Investigation into the remediation of the contaminated site at Mapua

Water quality technical annex

Figure 1: DDT concentrations in site monitoring wells

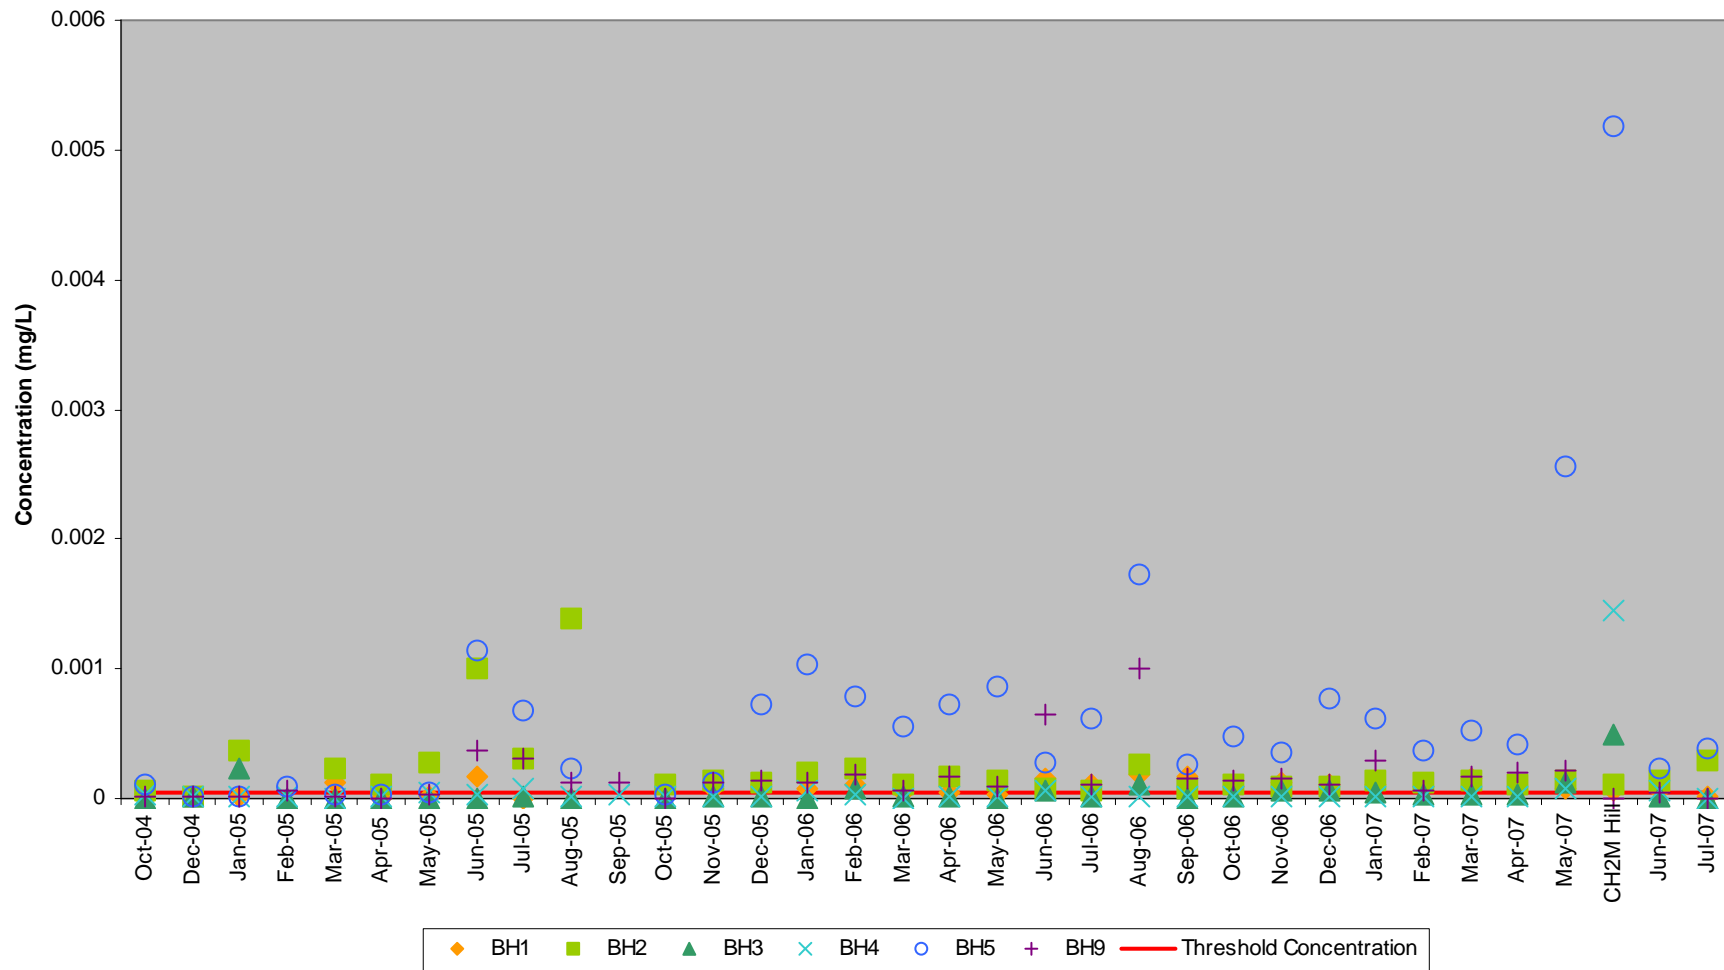
- **DDT** was generally well above threshold at the more southerly onsite monitoring wells, BH2, BH5 and BH9, throughout the works (see [Figure 1](#)). Results for BH1, BH3 and BH4 were generally around or about the threshold concentration. DDT was generally below threshold at residential wells, but as of July 2007 had exceeded twice at 26 Tahi St. The trends for **DDE** were similar. The concentrations of 0.22 mg/L DDX predicted in the AEE for 13 Tahi St have not eventuated.

[Figures 1](#) and [3](#) show a distinct increase in DDT and lindane results from June 2005 onwards. This coincides with the change in sampling protocol, but monitoring reports from the sampling contractor, ChemSearch, show that samples for pesticide analysis were centrifuged both before and after June 2005. The CH2M Hill (2007) report states that their pesticide samples were decanted, which may account for the high DDT concentrations seen during their investigation, particularly in BH5. (The site auditor had recommended that CH2M Hill filter samples for pesticide analysis.)

Figure 4: Nitrate concentrations in site monitoring wells

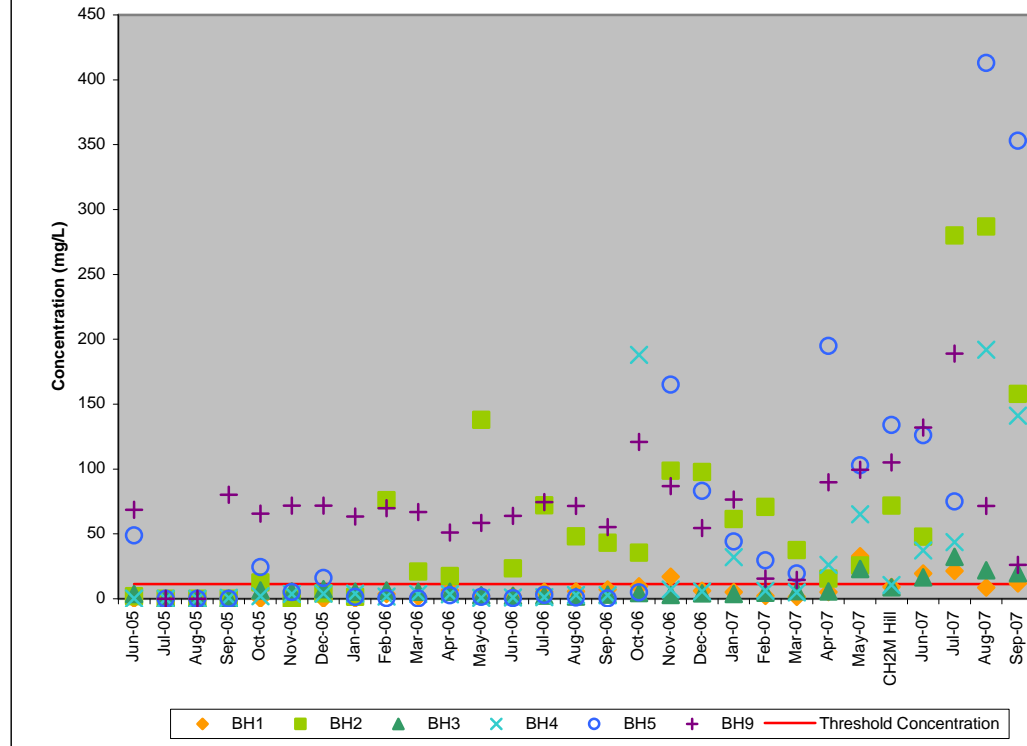
[Figures 4 and 5](#) show that nitrate concentrations at the southern site monitoring wells BH2, BH5 and BH9, and the residential bore at 26 Tahi St, have generally been well above the threshold concentration. From early 2007, nitrate began to exceed criteria at BH1, BH3 and BH4, and then at 13 Tahi St as well.
